SANTA MONICA MOUNTAINS CONSERVANCY

**Comments on Applications No. 4-04-026, 4-04-99, Agenda Items 17.b. and 17.d.,
July 13, 2005 California Coastal Commission meeting**

Applications No. 4-04-026 and 4-04-099 (Corral Canyon)

**Comments on Application No. 4-04-099, Agenda Item 15.c.,
April 13, 2005 California Coastal Commission meeting**

Exhibit A

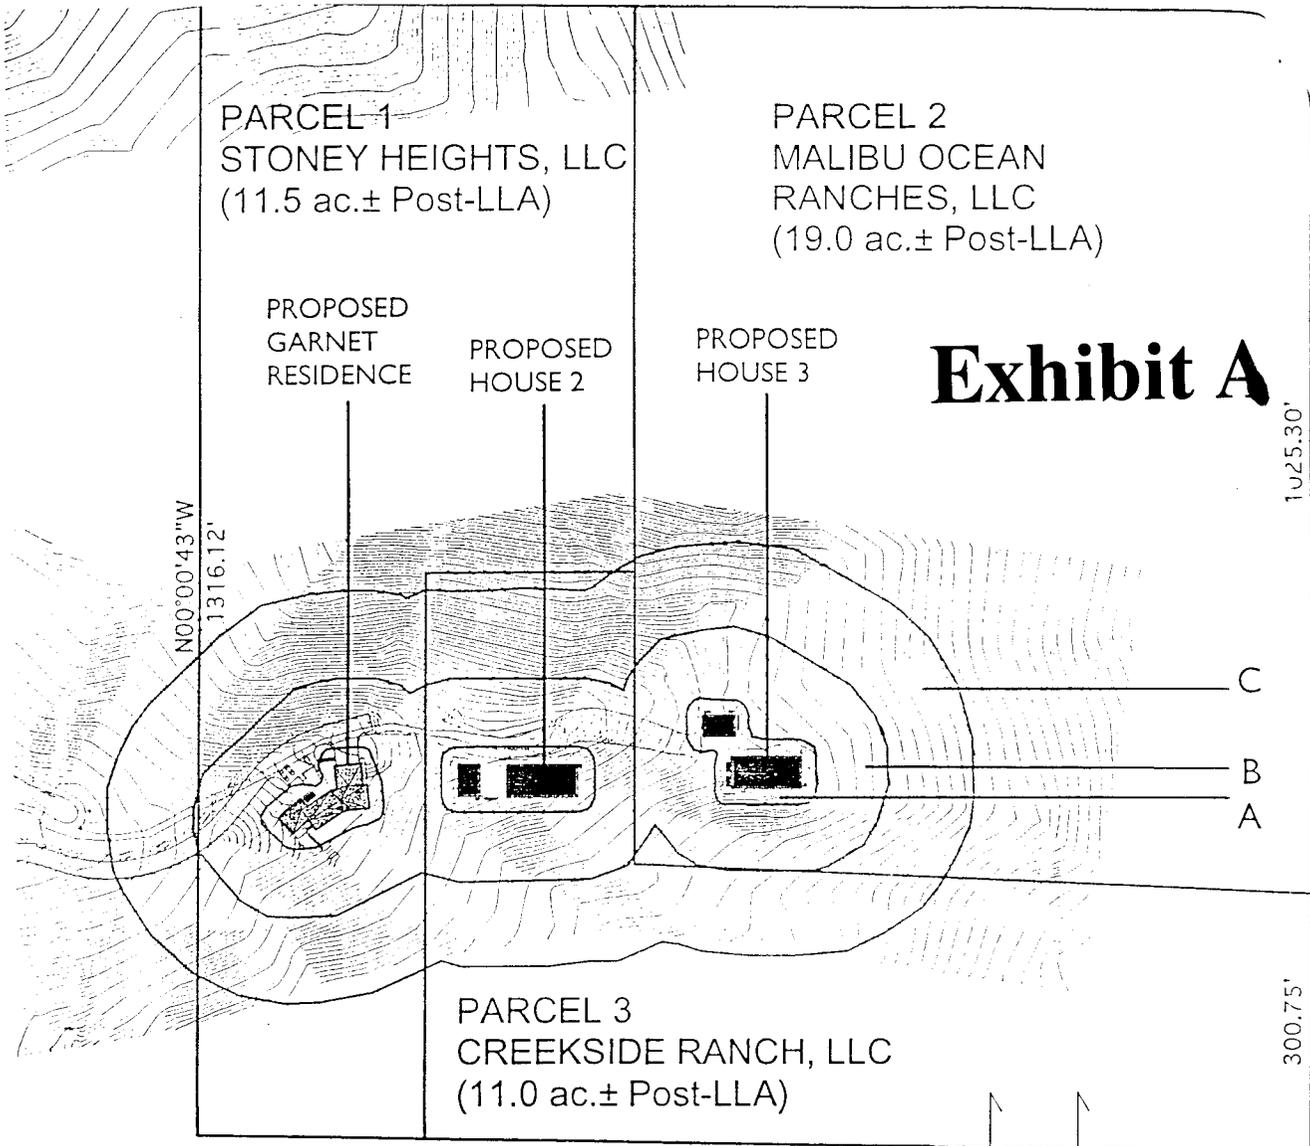
As background, this is the 3-parcel resubdivision approved by Coastal Commission (CDP Nos. 4-04-026, 099).
